BCA ASSESSMENT REPORT

BUILDINGS 8 & 12
8-12 UNIVERSITY AVENUE, MACQUARIE PARK

MACQUARIE UNIVERSITY

Revision 7

Source: KANNFINCH Drawing No. DA3.02 Revision J dated 2.11.2018

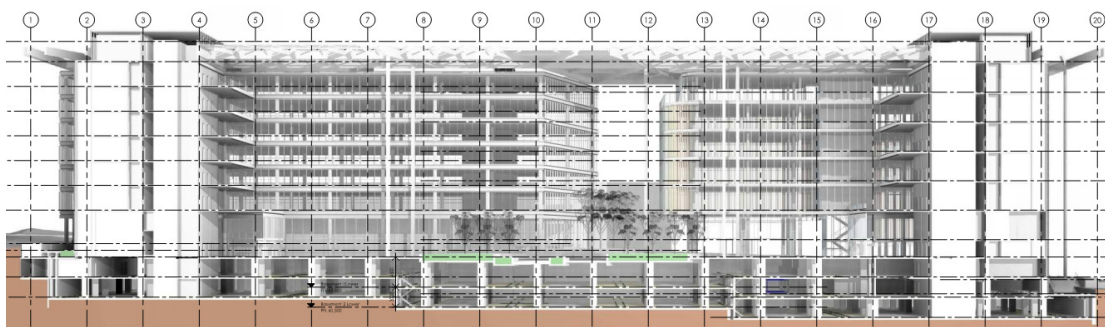
Note 1: The “Galleria” through site link area on ground floor is proposed to be partially covered with a louvered roof structure (for shade and aesthetic purposes only). Note 2: Given the louvered roof structure, the Galleria area may be considered substantially enclosed at the top in accordance with the definition of “Atrium” in BCA Clause A1.1. To this end, the provisions of Part G3 (as referenced in our comments below) will apply.
